Technical Service Bulletin

SUBJECT:		No: TSB-18-27-001	
TORQUE UPDATES: UNITS OF TIGHTENING TORQUE & NUMERICAL VALUE FOR REAR AXLE - SERVICE MANUAL REVISION		DATE: December 2018	
		MODEL: 2008-2014 Lancer Evolution	
CIRCULATE TO:	<input type="checkbox"/> GENERAL MANAGER	<input checked="" type="checkbox"/> PARTS MANAGER	<input checked="" type="checkbox"/> TECHNICIAN
<input checked="" type="checkbox"/> SERVICE ADVISOR	<input checked="" type="checkbox"/> SERVICE MANAGER	<input checked="" type="checkbox"/> WARRANTY PROCESSOR	<input type="checkbox"/> SALES MANAGER

This TSB updates the Rear Axle section of the affected Service Manuals to correct the tightening torque for the Differential Carrier Assembly.

REMOVAL AND INSTALLATION

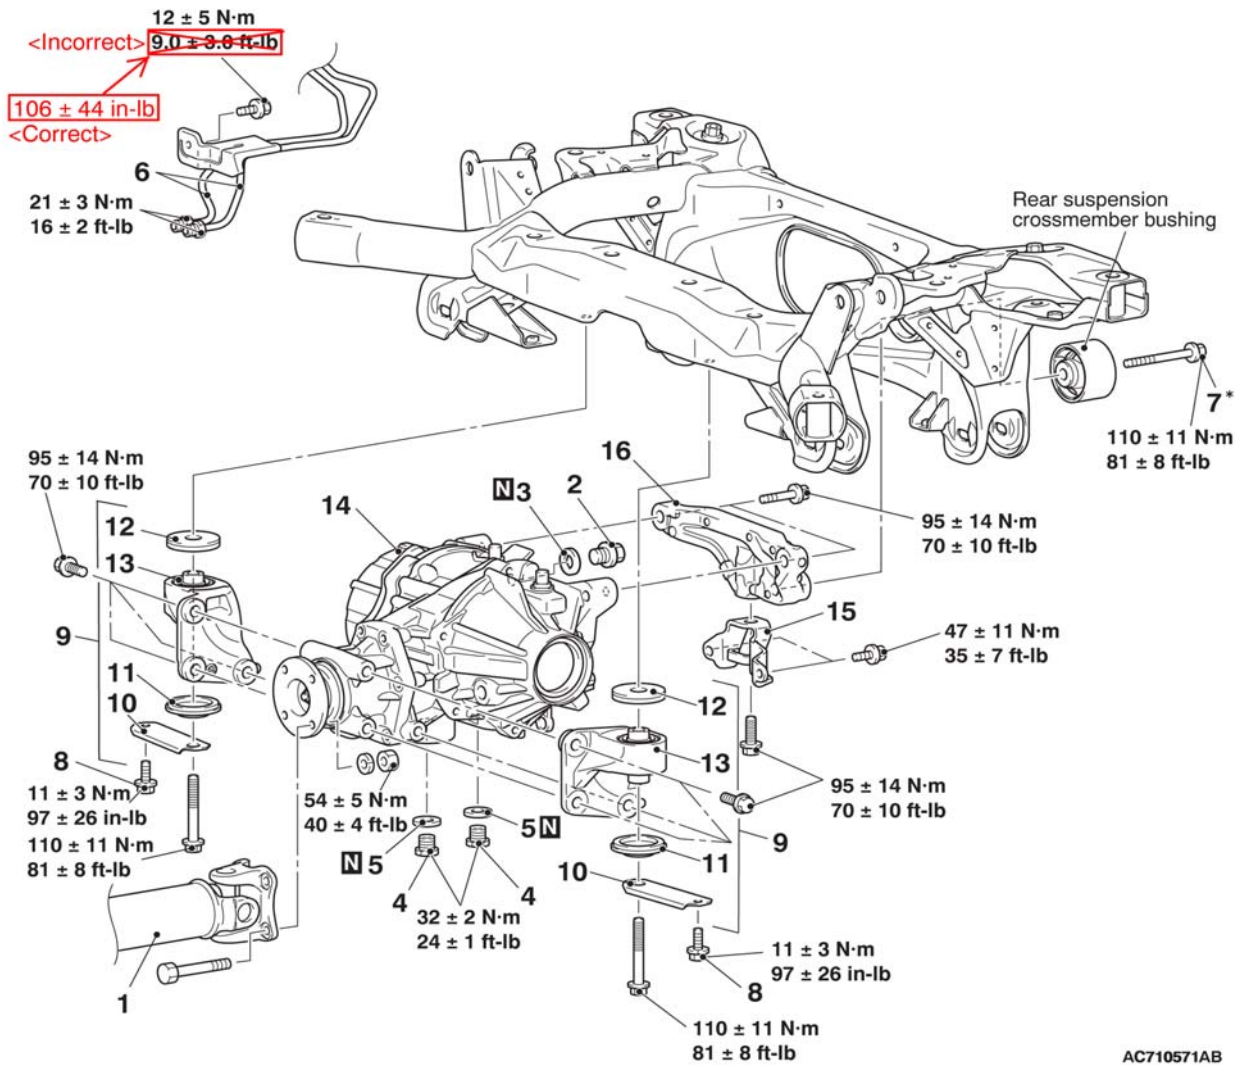
Please make the indicated changes to the 2008 - 2014 Lancer Evolution Service Manual, Group 27 - Rear Axle -> Differential Carrier Assembly -> Removal and Installation.

- The part indicated by * is the bolt with friction coefficient stabilizer. In removal, ensure there is no damage, clean dust and soiling from the bearing and thread surfaces, and tighten them to the specified torque.
